**RE: Standard Dredge and Fill Wetlands Permit Application (RSA 482-A)
NHDES File Number: 2022-03478
Subject Property: Barrett Hill Rd, Wilton, Tax Map #A, Lot #44-1**

Per your request for more information dated February 21, 2023 please see clarification below and attached.

On behalf of the Town of Wilton Planning Board, Aries Engineering, LLC (Aries) prepared this letter report to describe our engineering review of available subdivision plans and the drainage report for a 7-Lot Subdivision, proposed by San-Ken Homes, Inc. (Applicant) of New Ipswich, New Hampshire, for an approximate 45-acre +/- parcel identified as Tax Lot A-44-1 (site property) and located on Barrett Hill Road in Wilton, New Hampshire. A site locus plan is depicted on Figure 1.

ALTERNATIVE DRIVEWAY CONCEPT PLAN

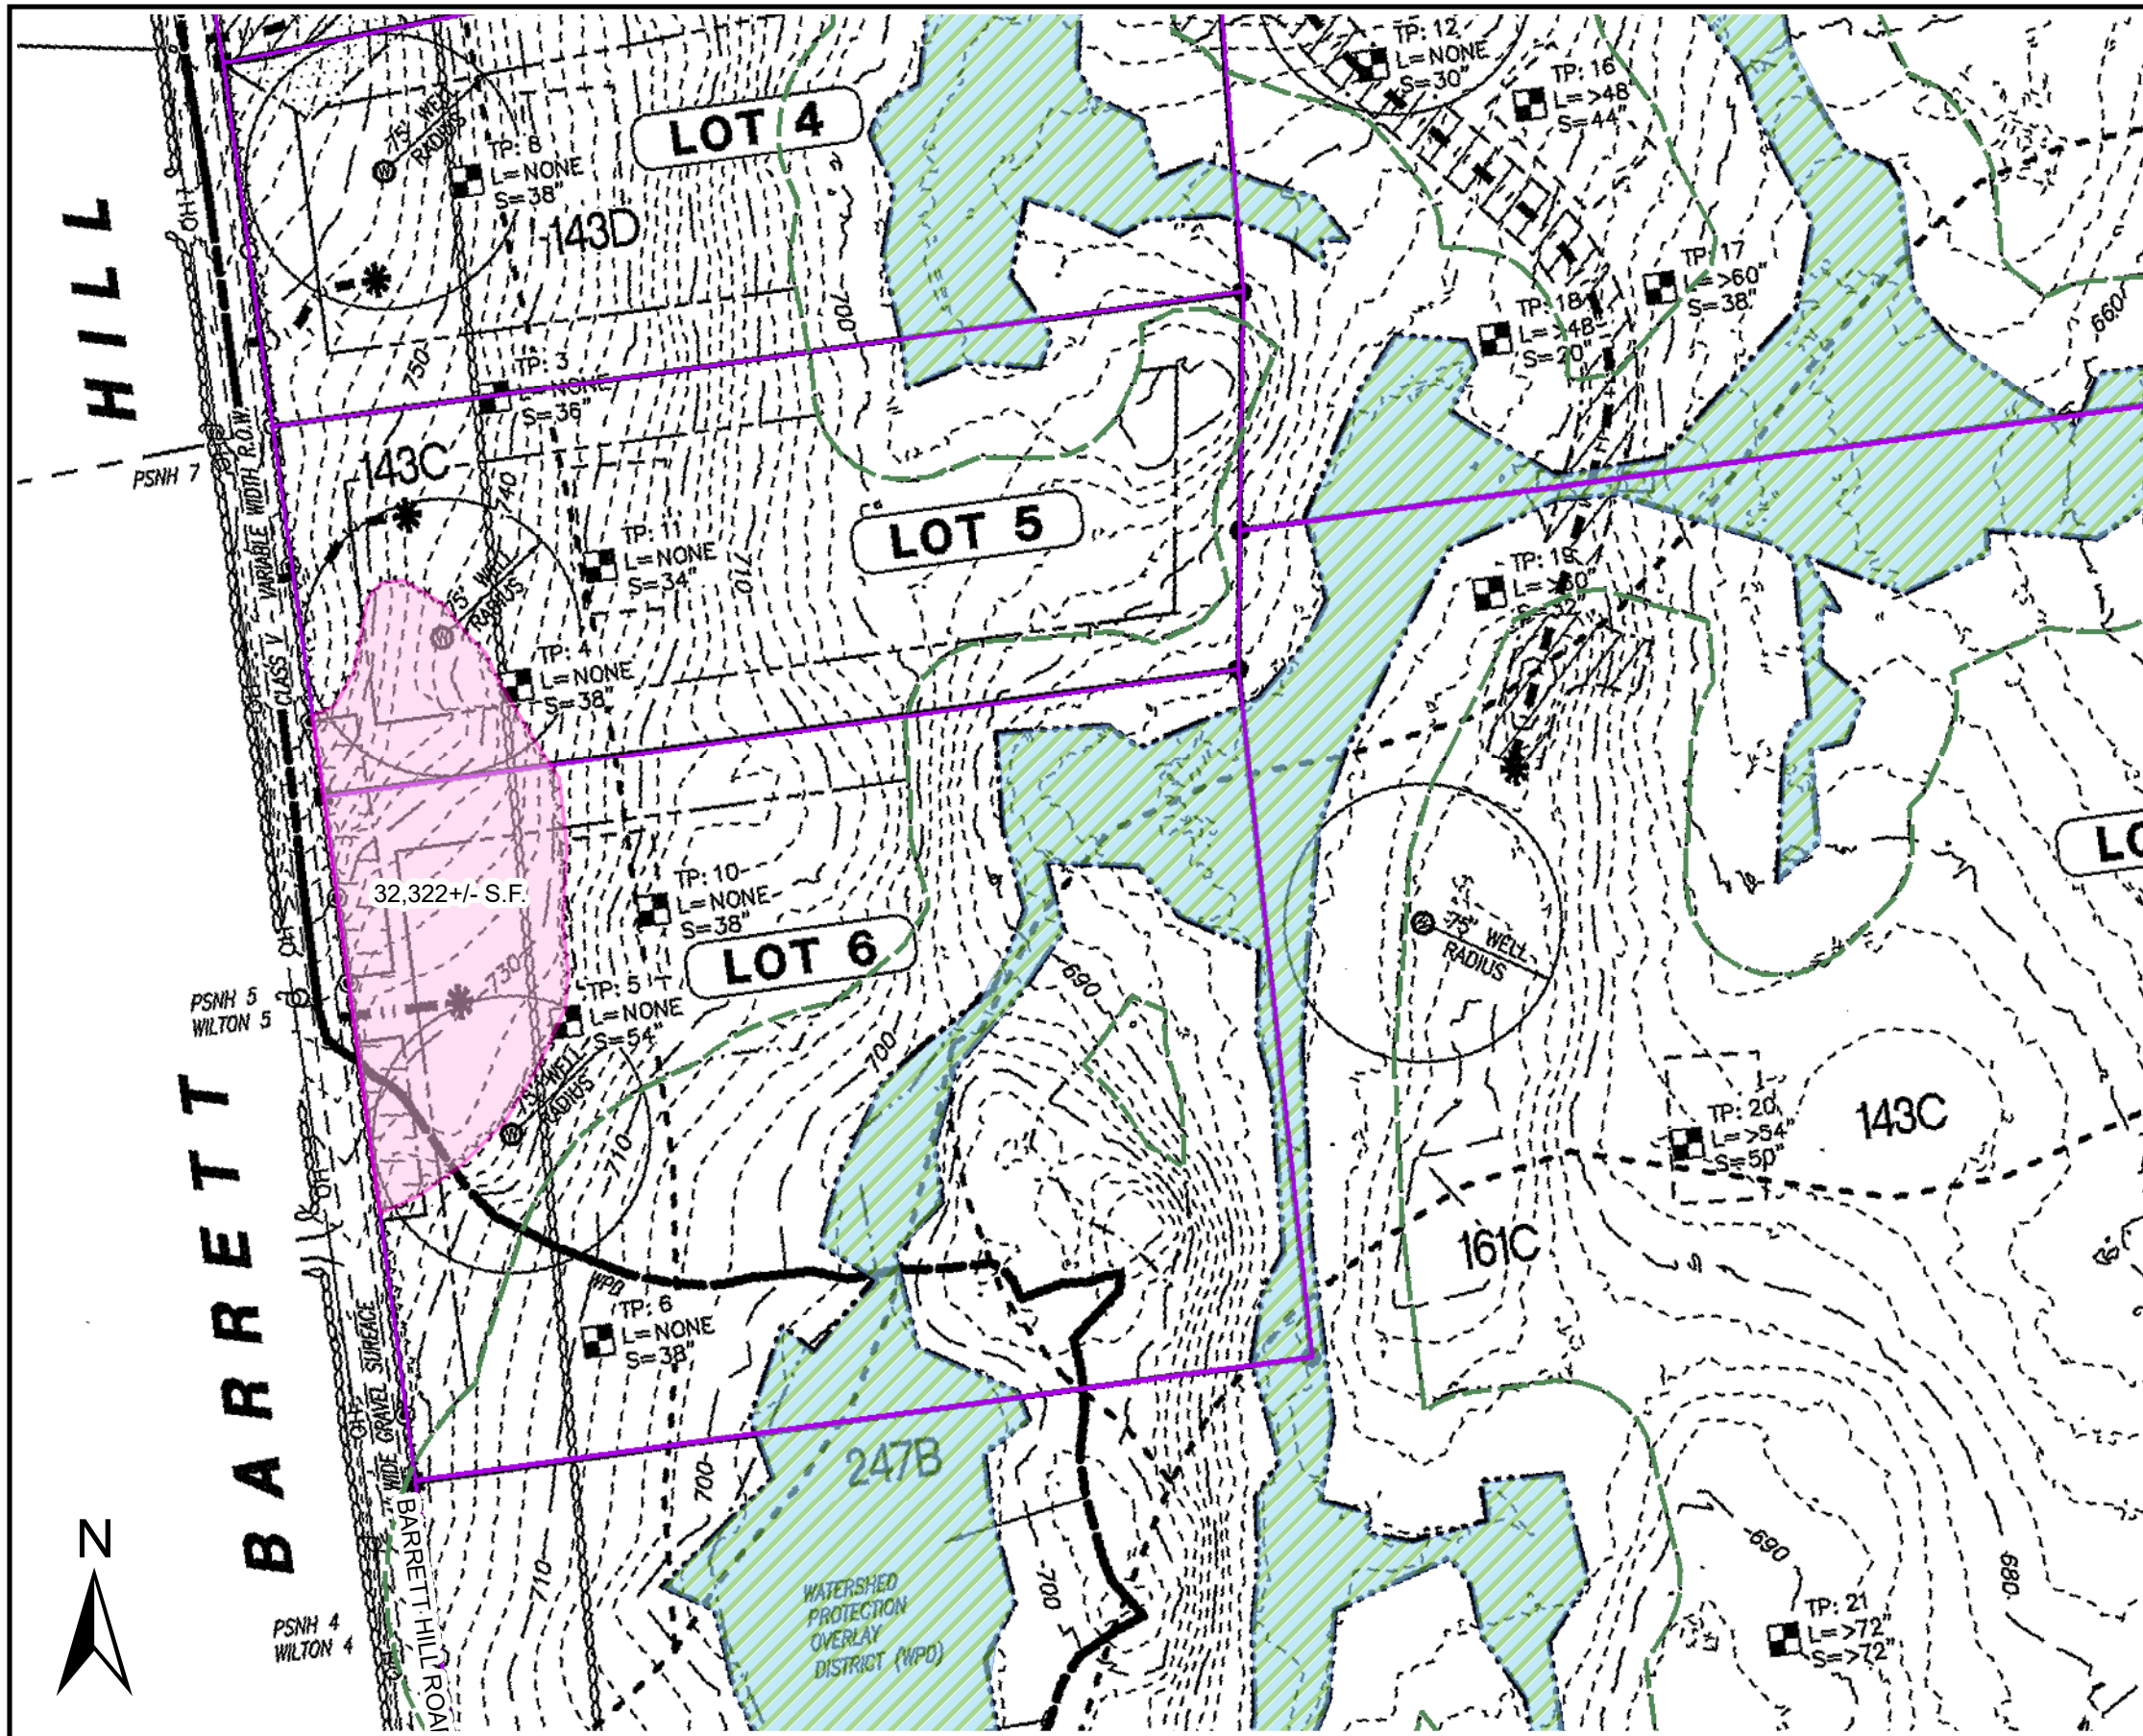
existing woods road. Attached Figure 4 depicts a concept plan of the proposed alternative driveway.

EXISTING DISTURBANCE AREA PLAN

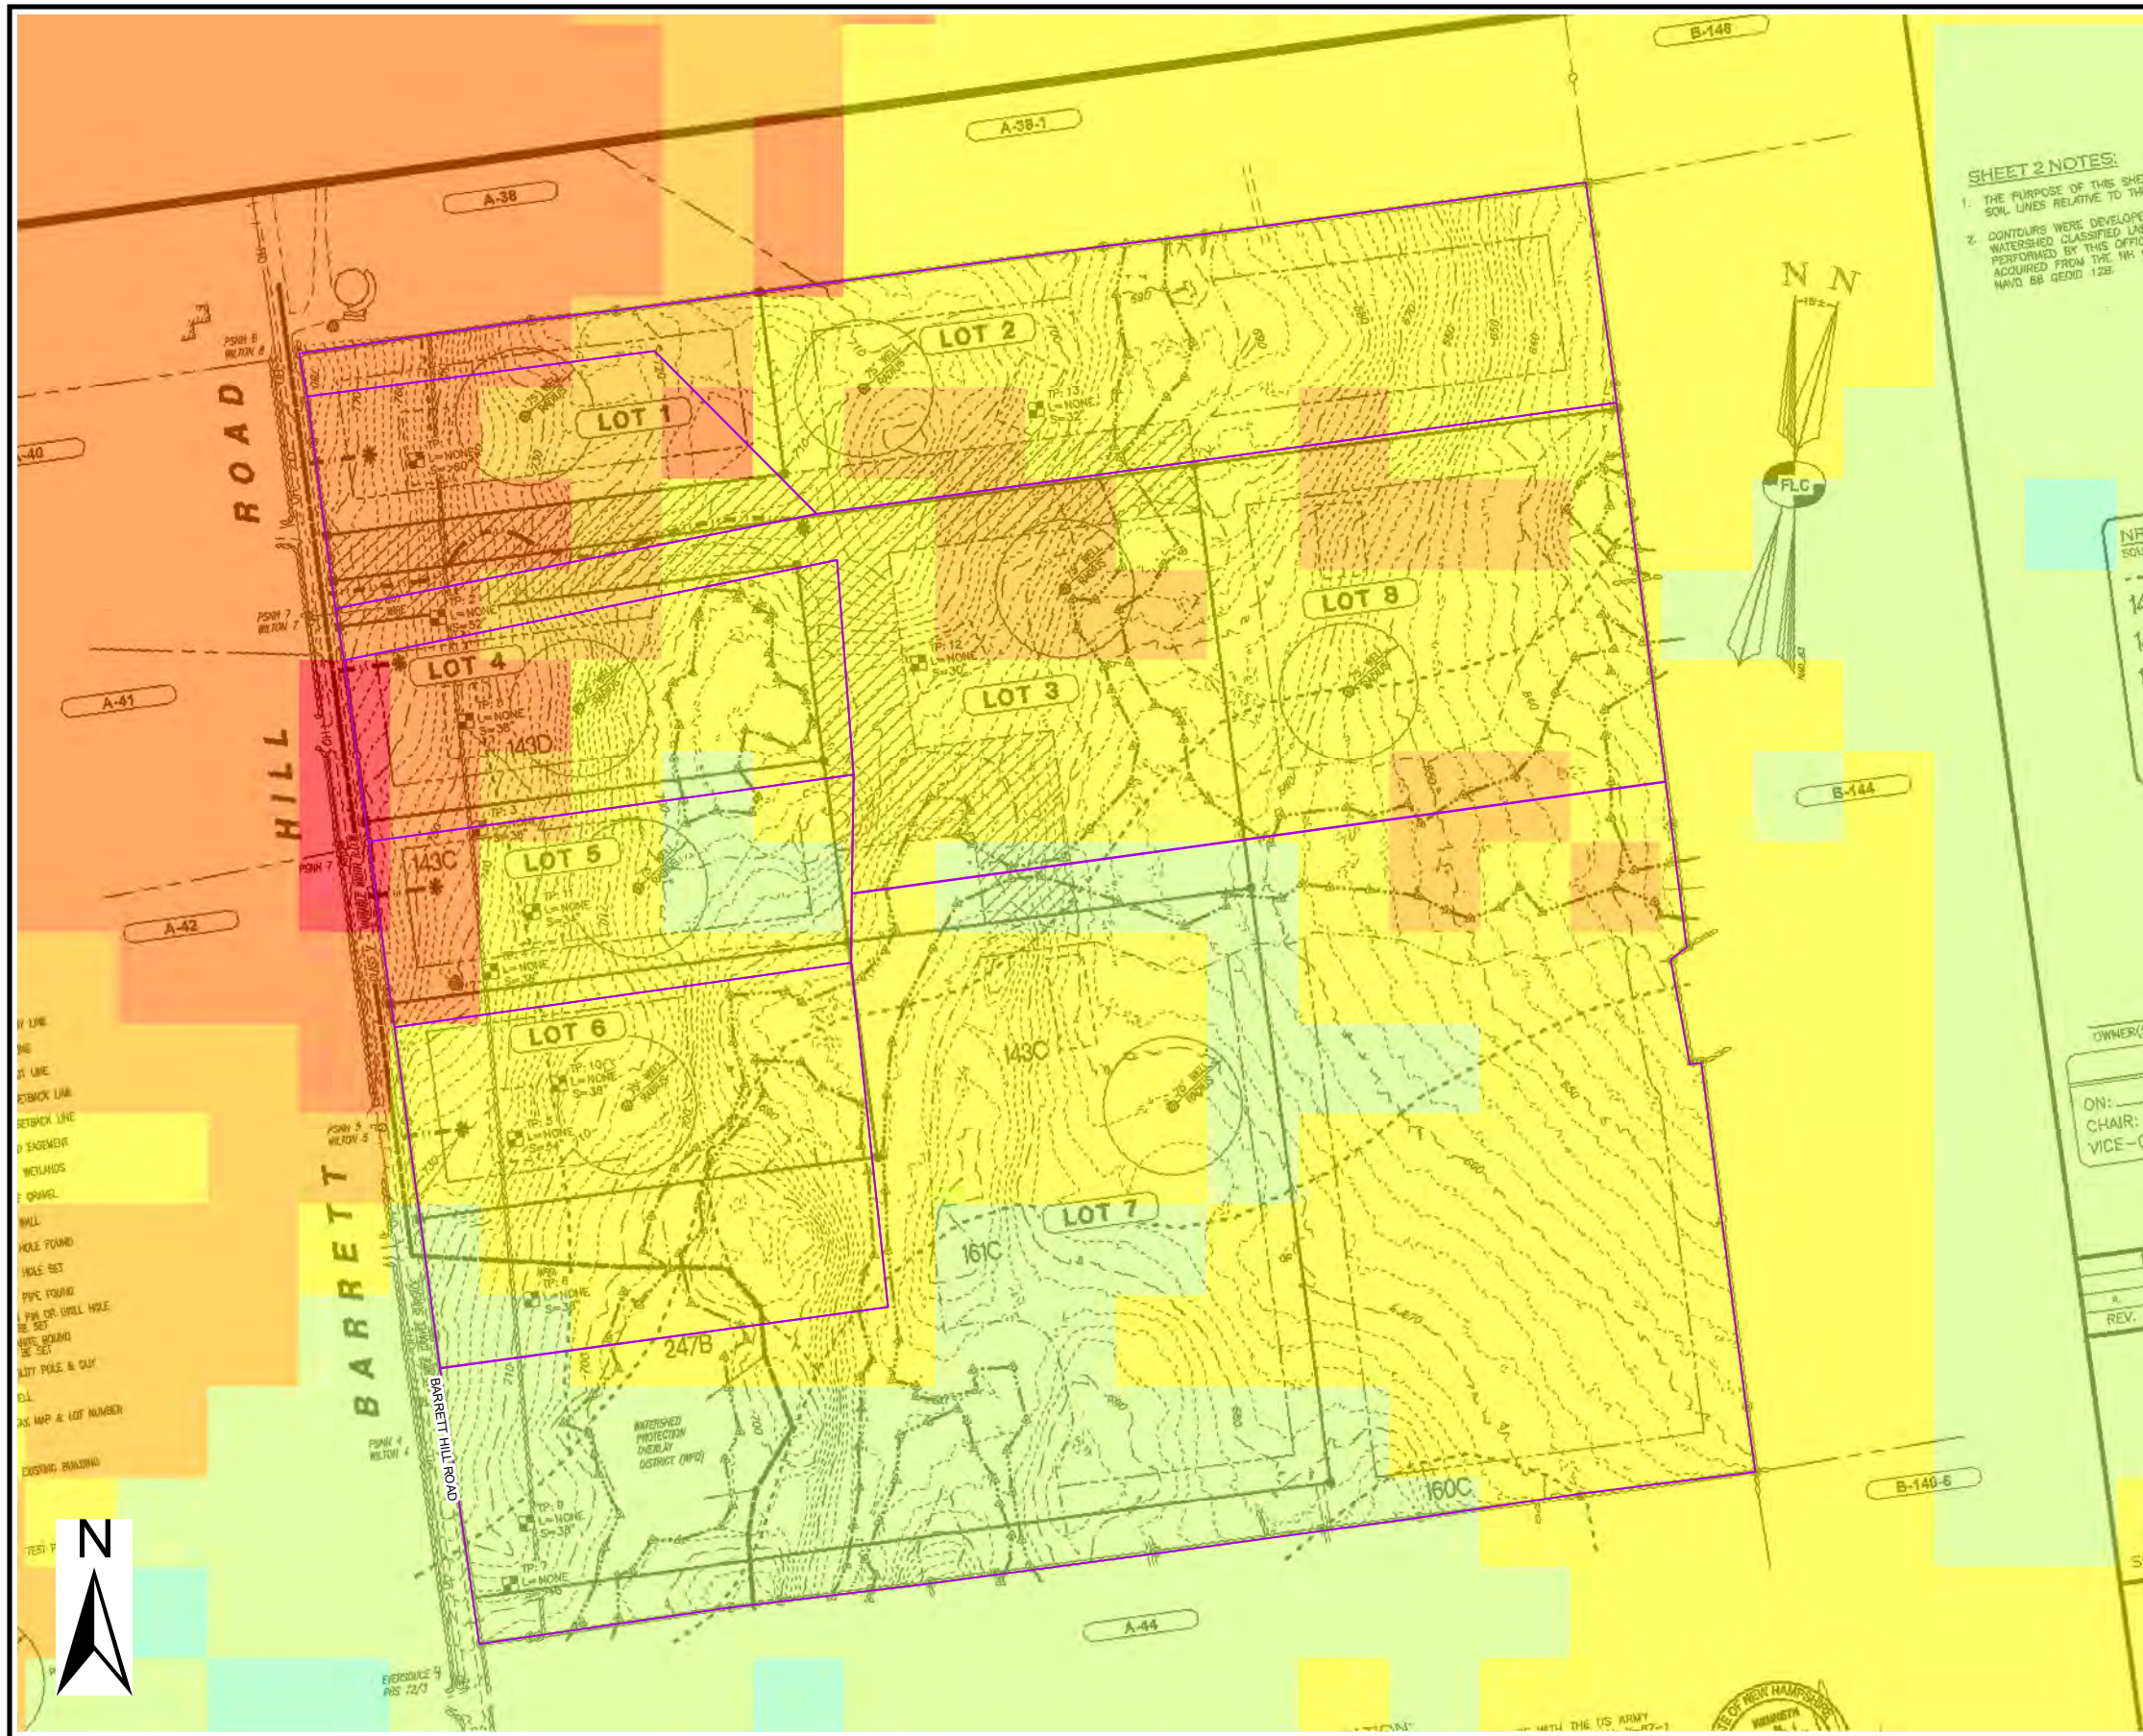
- Lots 5 and 6. Attached Figure 5 depicts the pre-development land clearing disturbance area, which is based on the treeline depicted on the site plans.

NH BEDROCK-YIELD PROBABILITY PLAN

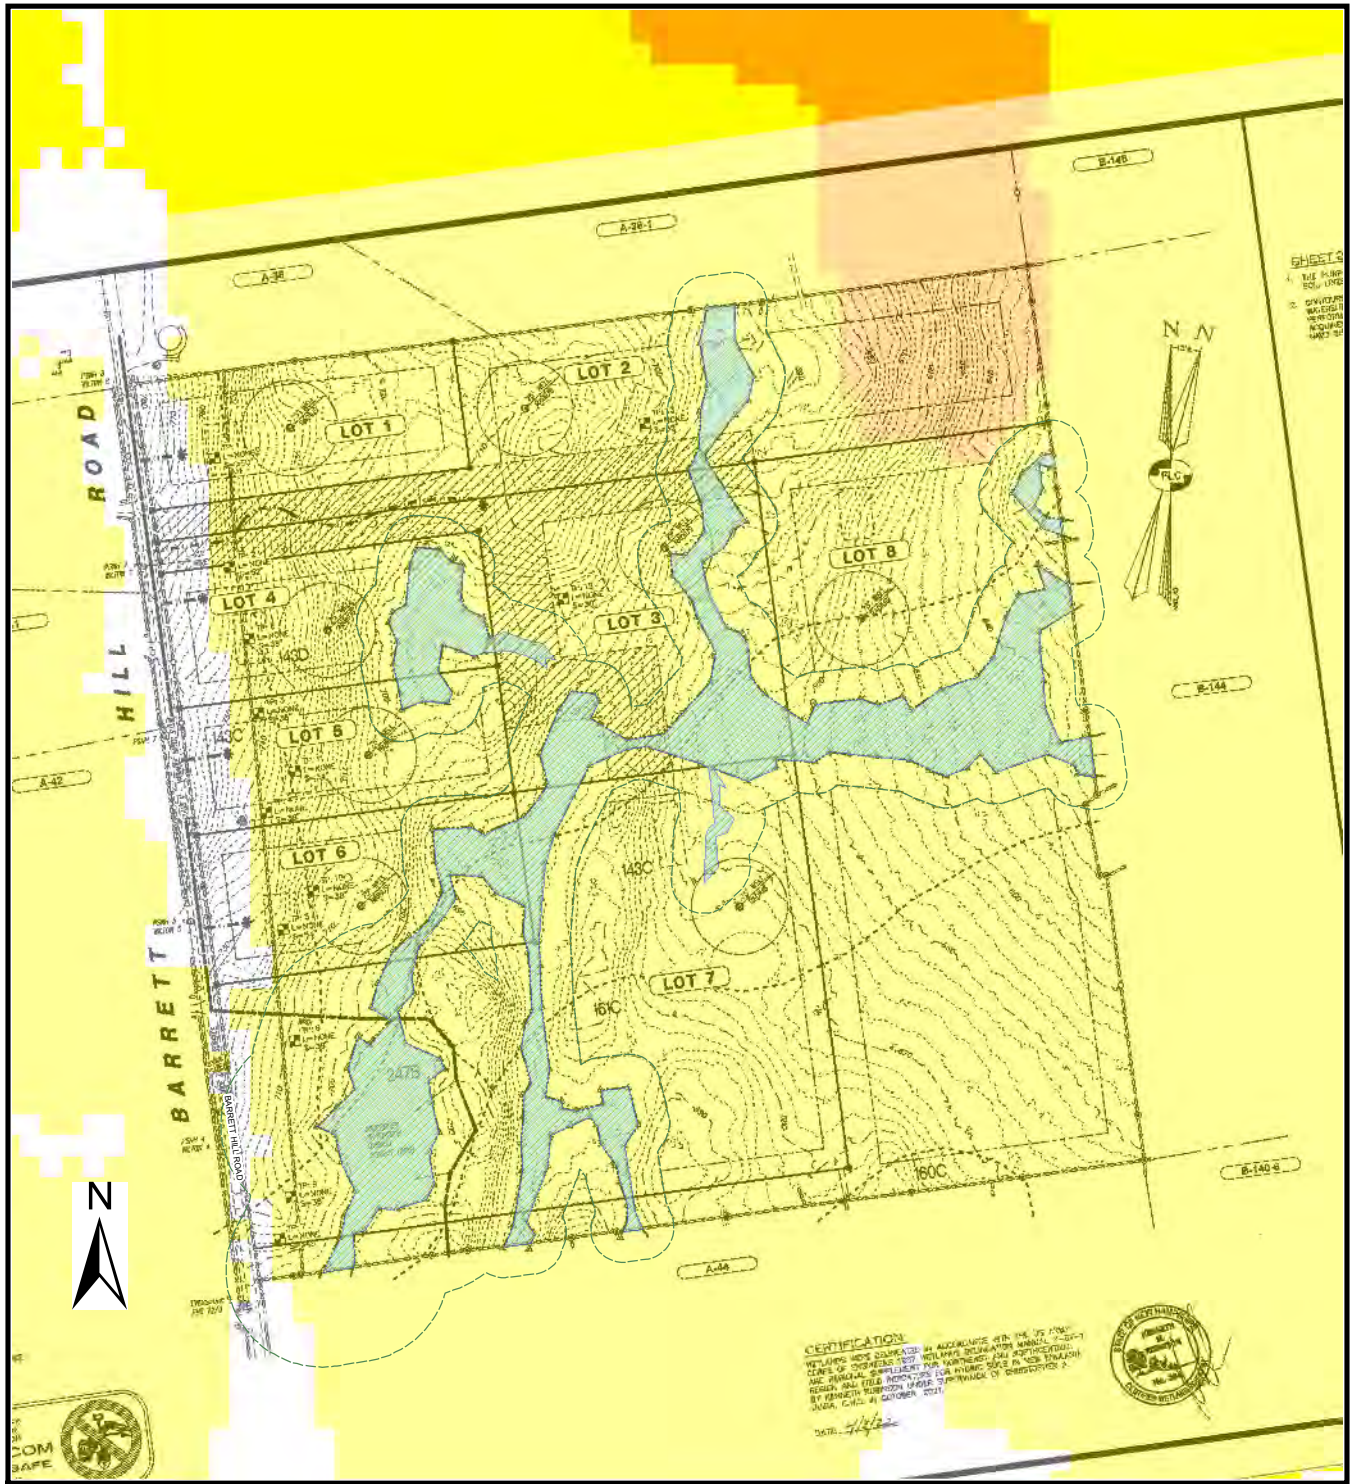
From 1994 to 2002, the USGS, in cooperation with NHDES, investigated the yields of wells in New Hampshire's bedrock aquifer³ (NH Bedrock-Yield Probability Study). Attached Figure 6 depicts the NH Bedrock-Yield Probability Study findings, which predict an 8% to 15% probability of drilling a high yielding (greater than 40 gpm) bedrock well in the proposed development area on the site property.
